Westinghouse BWR ECCS Evaluation Model:
Supplement 5 – Application to the ABWR

May 2014

SUBJECT: FINAL SAFETY EVALUATION FOR SOUTH TEXAS PROJECT WCAP-17116-P,
“WESTINGHOUSE BWR ECCS EVALUATION MODEL: SUPPLEMENT 5 –
APPLICATION TO ABWR”

Figure 13-1 - Dome Pressure, ECC Flow and Flows Between RPV Regions For Feedwater Line Break

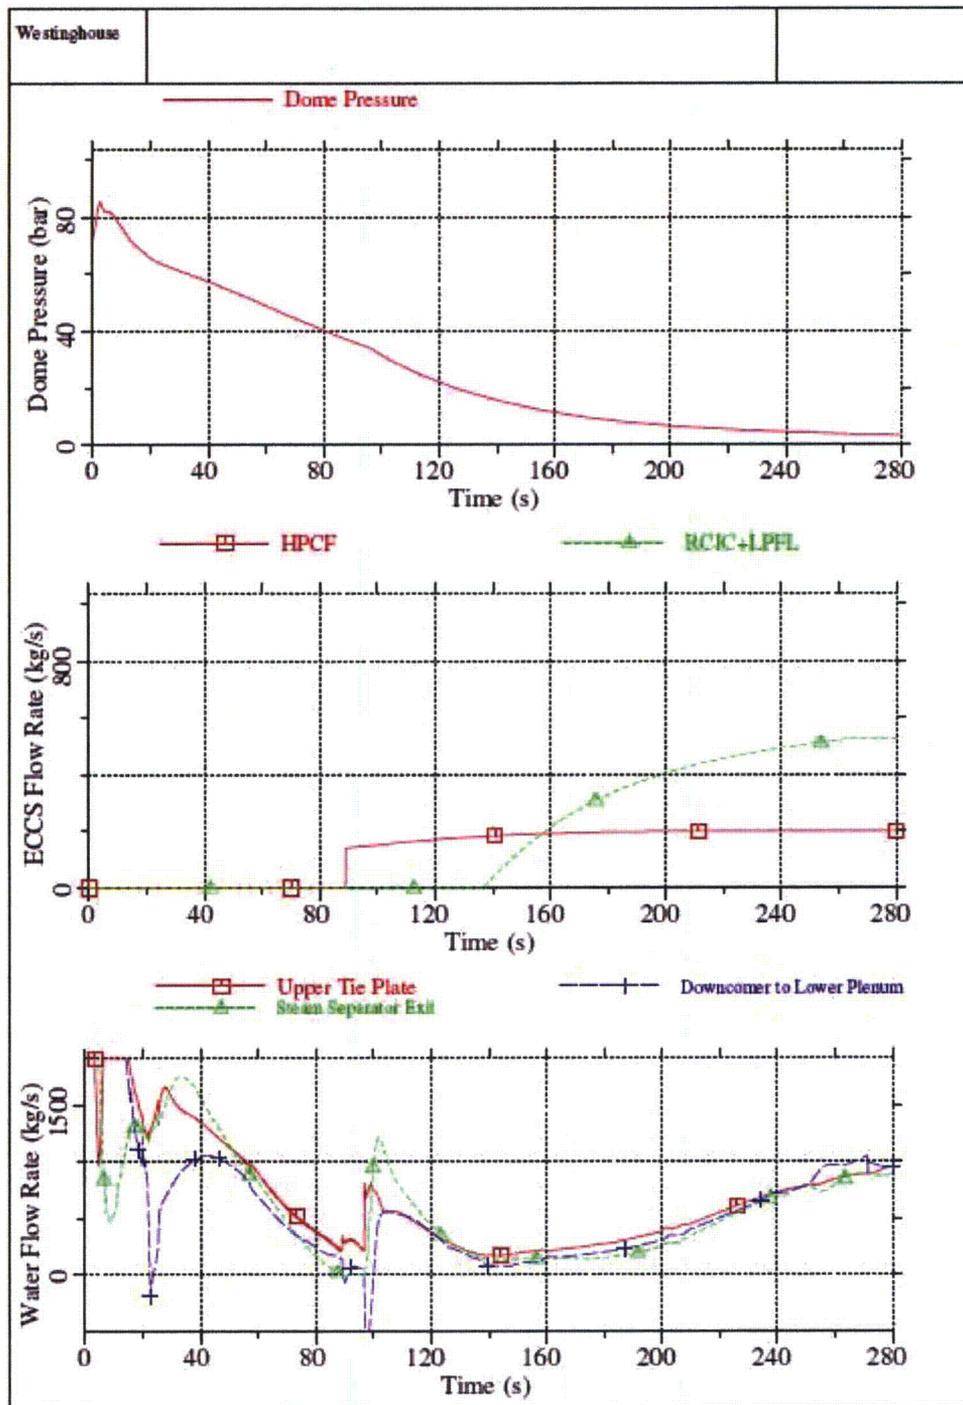
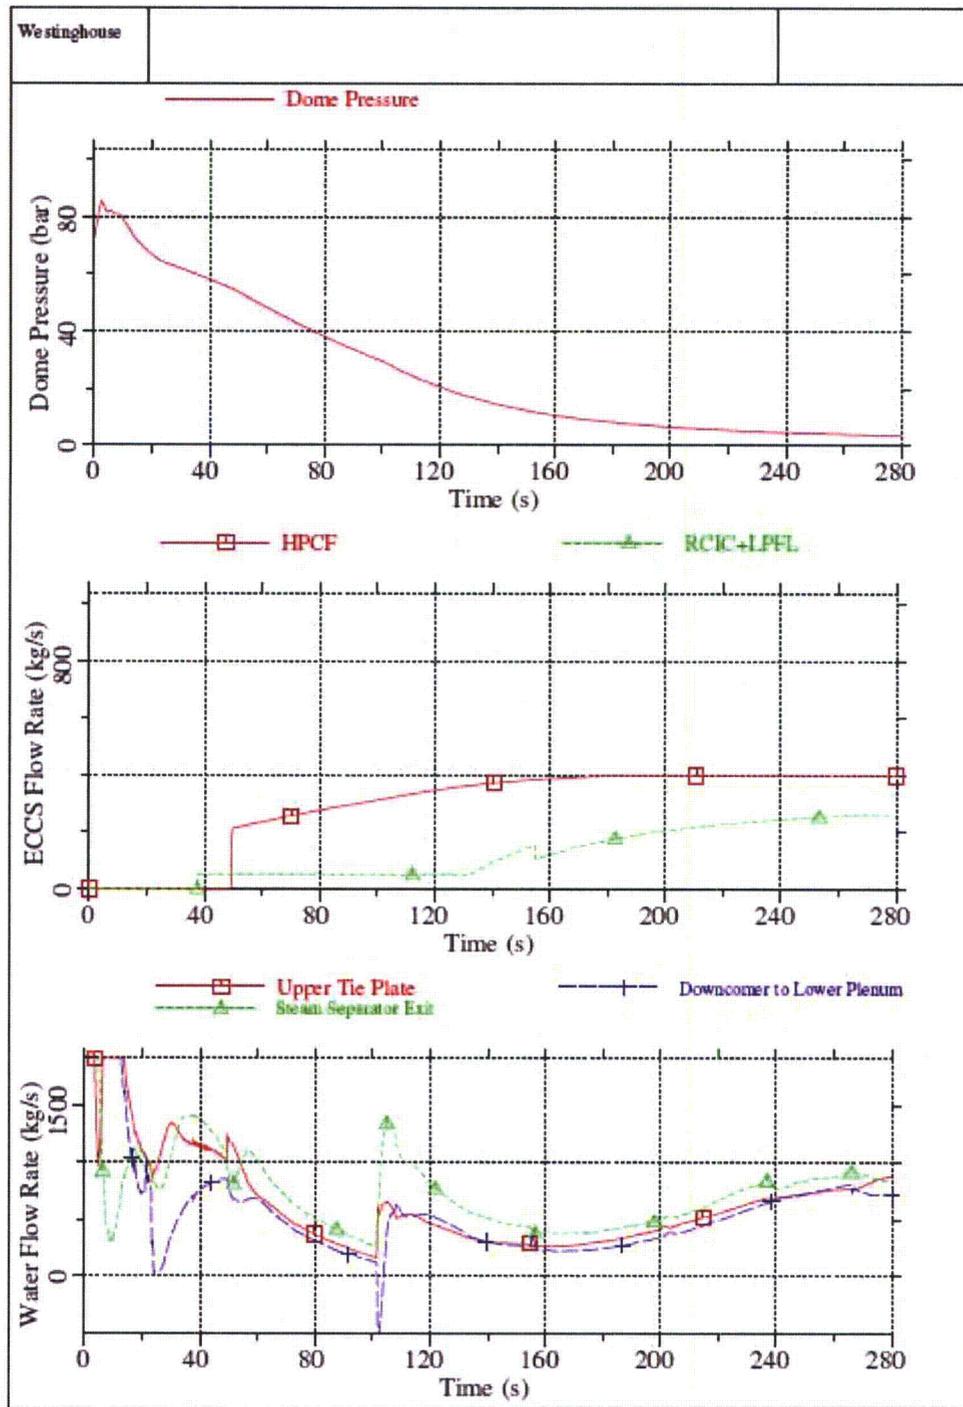
While HPCF adds inventory to the upper plenum, the details of how HPCF flow distributes in the upper plenum region is not important because HPCF water mixes with the upward flow from the reactor core and overflows into the downcomer via the steam separators, thus not requiring finer nodalization.

Figure 14-1 - Dome Pressure and LPFL Flow for Feedwater Line Break

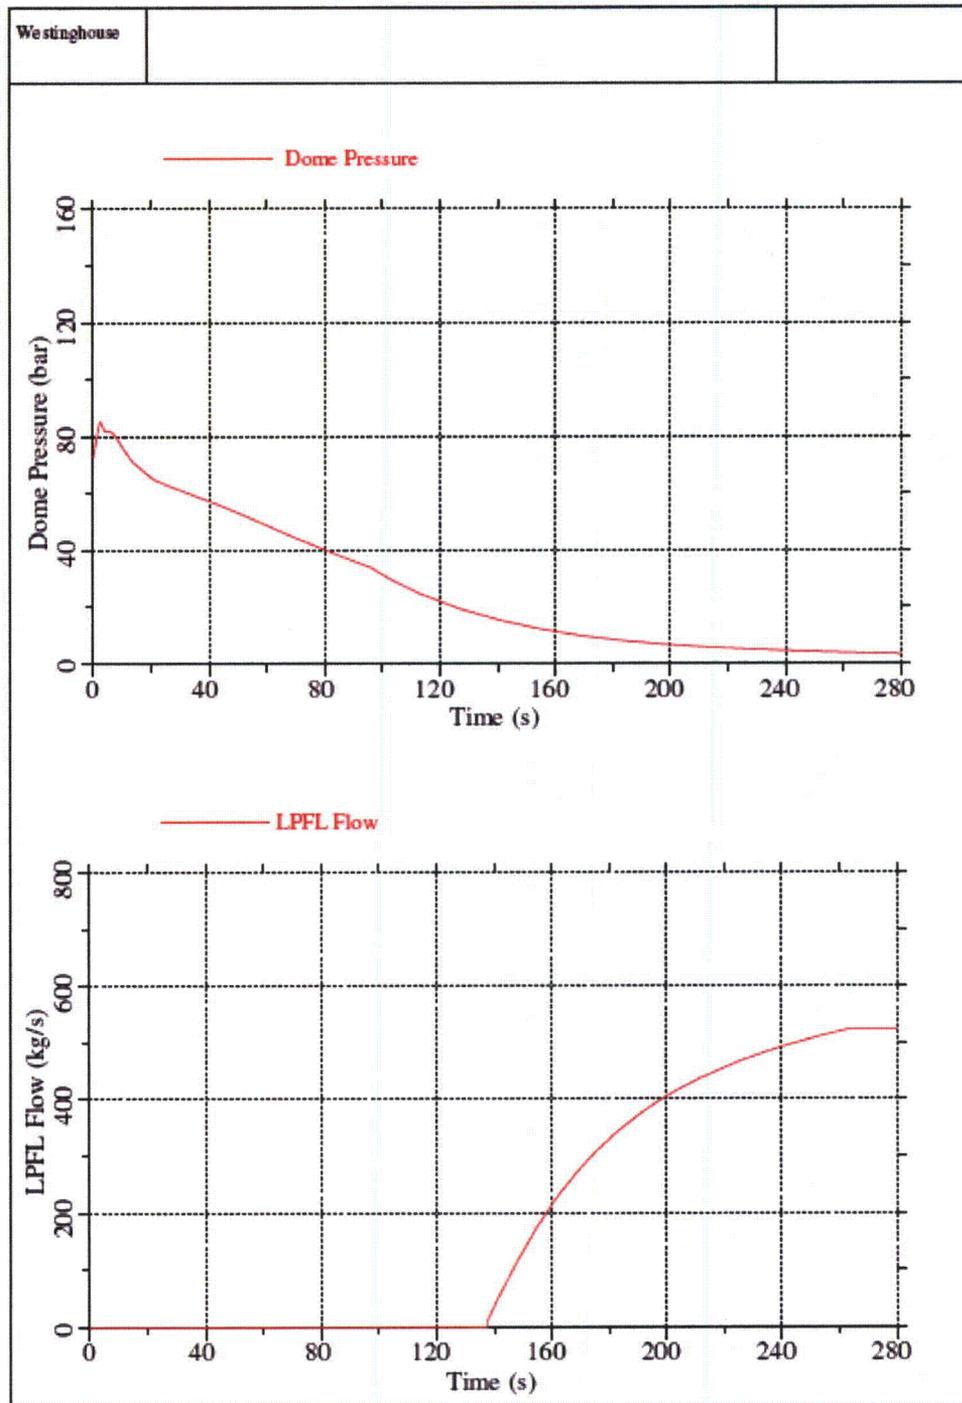
- d) One of the conditions for activating the LPFL is low reactor vessel pressure. As shown in Figure 14-1 for the limiting feedwater line break case, the vessel pressure continues to decrease following the injection of LPFL. The continuous depressurization produces spontaneous flashing of water in the lower plenum and downcomer. Figure 14-2 compares the two-phase mixture level and wide range level to the LPFL injection elevation. This figure shows the existence of a two-phase mixture as the two-phase mixture level exceeds the 'collapsed' wide range measured level. The figure also shows that the LPFL coolant must fall a considerable distance through a steam environment where there is an upward vapor flow. Because the LPFL water is distributed in the downcomer via nozzles on the LPFL sparger, there is a large surface area between the water jets / droplets and the vapor in the upper downcomer. Although the code forces the liquid to be in thermal-equilibrium with the vapor, this is also expected to occur in a best-estimate calculation. Furthermore, the flashing of water to steam in the lower plenum and downcomer produces vigorous mixing of any water that remains subcooled, ensuring a uniform thermal condition at the core entrance.

Figure 1 – Nodal Quality Upstream of ADS Valves

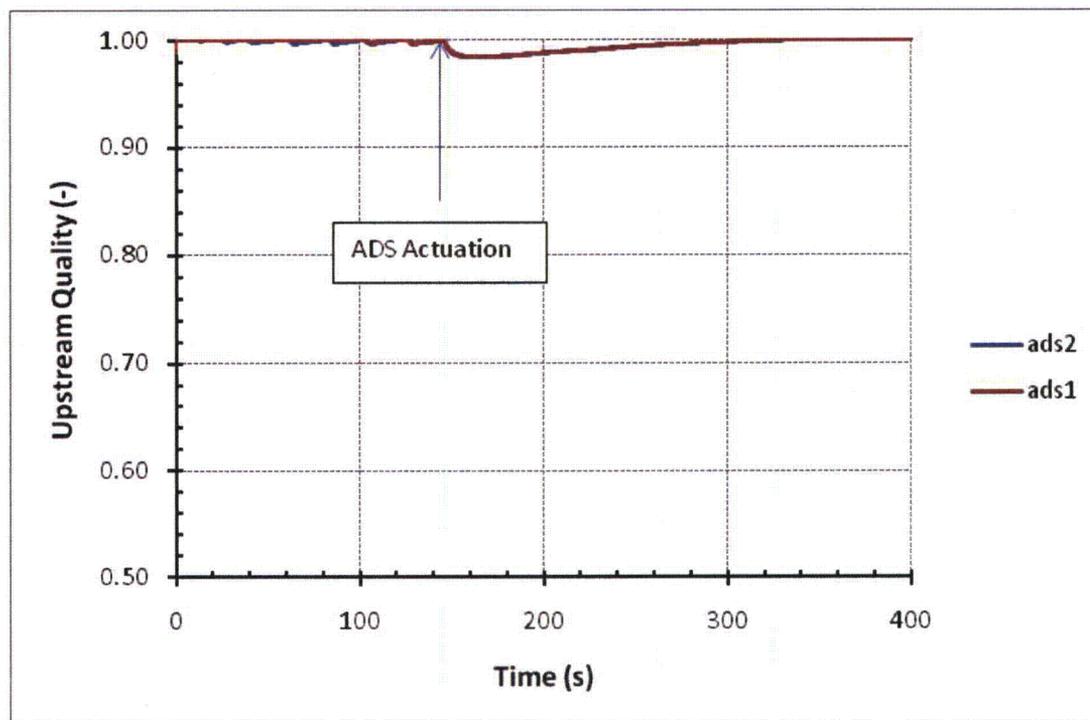
actuation for recovery that is described in WCAP-17116. The figure shows that the condition upstream of the ADS valve is high quality or single phase steam. There are two curves shown in Figure 1, because the ADS valve flows are split between the two steamlines represented in the GOBLIN model. As shown, there is a time interval immediately after the ADS valves open when the mixture in the downcomer swells to the elevation of the steam lines, which causes the quality upstream of the ADS valves to decrease to ~ 0.98 . Similar upstream conditions are expected for other scenarios that rely on ADS for system recovery.

Figure 2 – Comparison of Moody and HEM for Single Phase Vapor

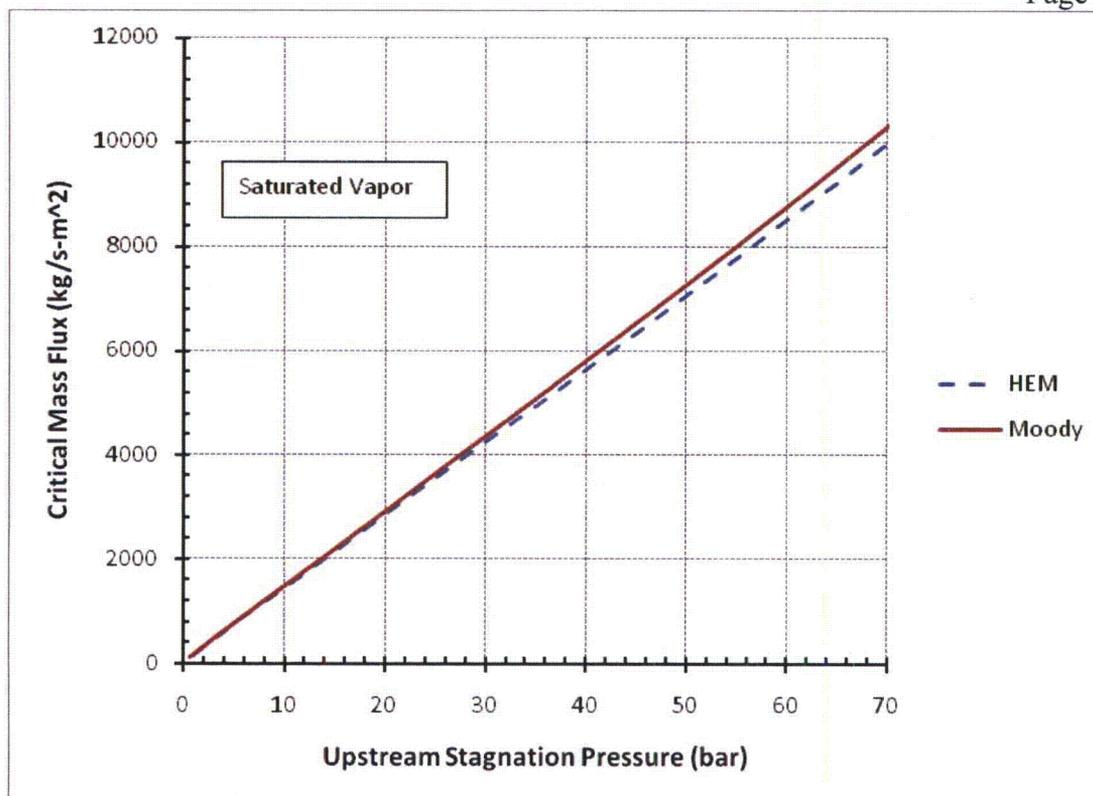
Figure 2 compares the two critical flow models for single phase steam. As shown, the predicted flow rates are nearly identical. Therefore, very little difference is expected in the system response if the ADS flow model were changed from HEM to Moody.

Figure 3 – Comparison of Total System Mass (hpcf4)

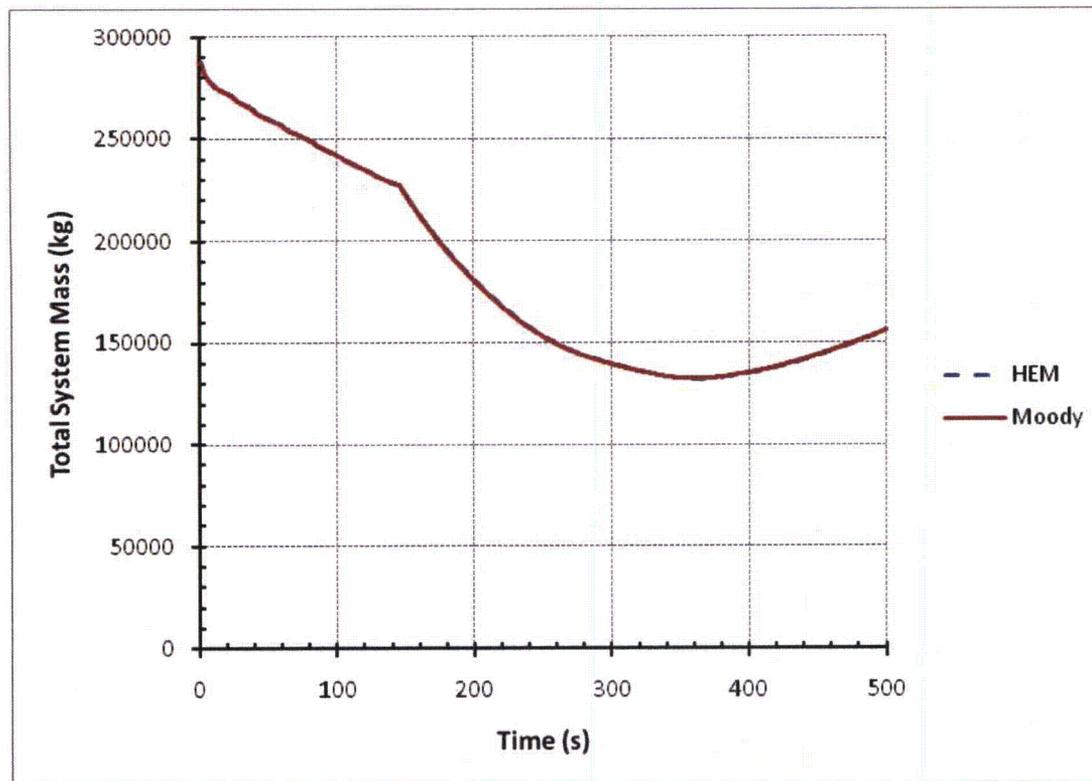
A sensitivity study was performed to demonstrate that the predicted system responses using the HEM and Moody models are nearly identical. Because the Moody model predicts slightly higher steam flow than HEM at ADS capacity reference pressure, the effective ADS flow area is reduced slightly so that the ADS flow capacities are identical at the reference pressure. The HPCF line break hpcf4 was used for this study, because it relies on ADS to actuate injection from the low pressure flooders (LPFL) pumps. A comparison of the predicted system inventories is presented in Figure 3. As shown, the system inventories are essentially identical. The results show that the difference in minimum system inventories is only 213 kg. The minimum system inventory occurs when the HEM model is used. Because core uncover is limited to partial uncover of lower powered assemblies, minimum system inventory rather than peak cladding temperature is used as an indicator for this study.

Figure 19-1 – Axial Power Peaking Factors for Different Burnups**

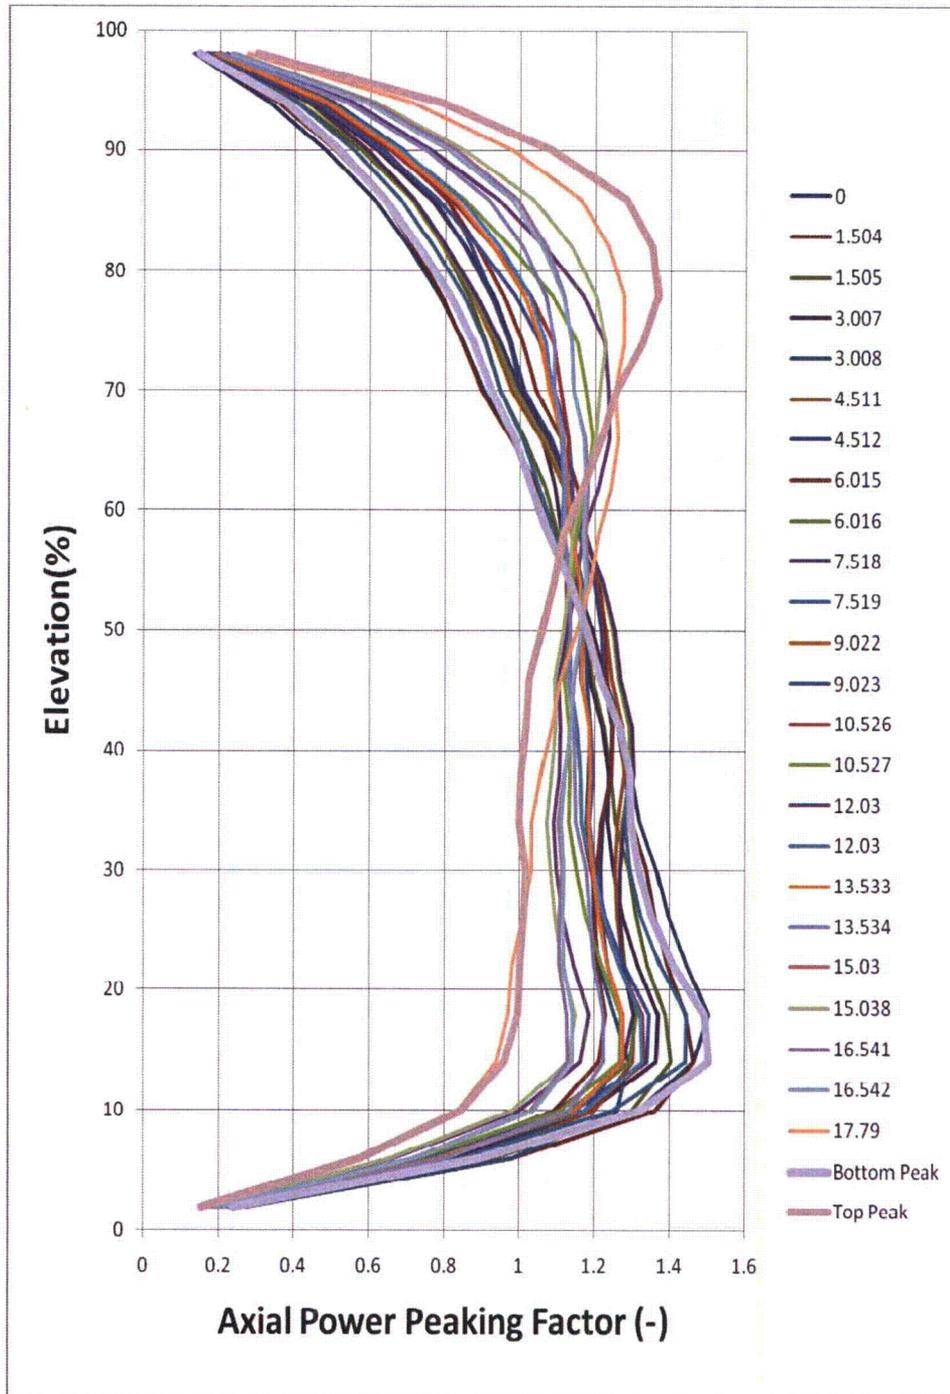
- a) Various normalized axial power shapes with associated axial power peaking factors (APPF) for a typical cycle depletion are shown in Figure 19-1 below for multiple burnup steps from 0 to 17.79 MWd/kg.

Figure 19-2 – Comparison of Void Fractions at Various Nodal Elevations for Three Axial Power Shapes

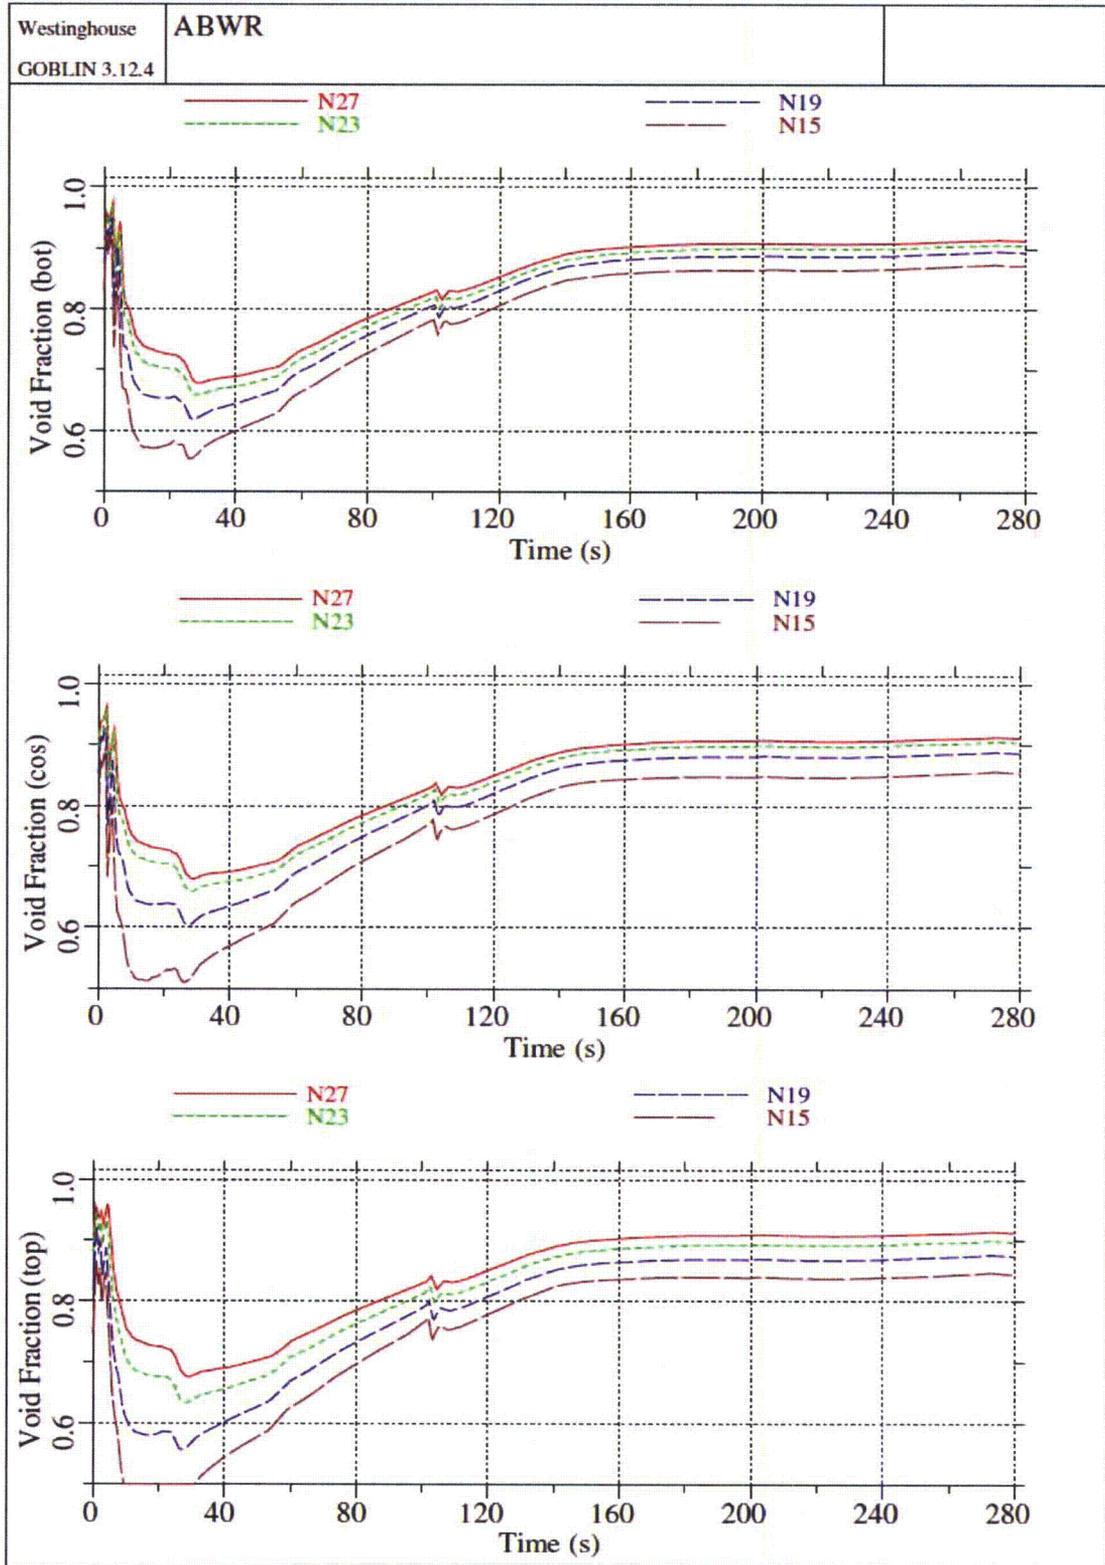
- b) Figure 19-2 shows the void fraction in the hot assembly for each of the axial power shapes at various axial elevations. This indicates that the void distribution is different for each power shape, but the outlet void fractions are nearly the same. This is to be expected since the integrated power up to the outlet is the same in all cases. The previous section concludes that the maximum PCT still occurs for the chopped cosine axial power shape. WCAP-11427-P-A discusses earlier dryout and uncover times for a top-peaked shape but this is for a BWR design with external recirculation piping and jet pumps. The ABWR design with rapid coastdown of the RIPs produces an early boiling transition before the reactor scram occurs. The increased voiding results in a reduction in core power, and along with reactor scram, further results in a rapid decrease in cladding temperature. Additionally, since the elevation of potential large pipe breaks is above the core, along with a robust ECCS, there is not an extended core uncover in the ABWR.
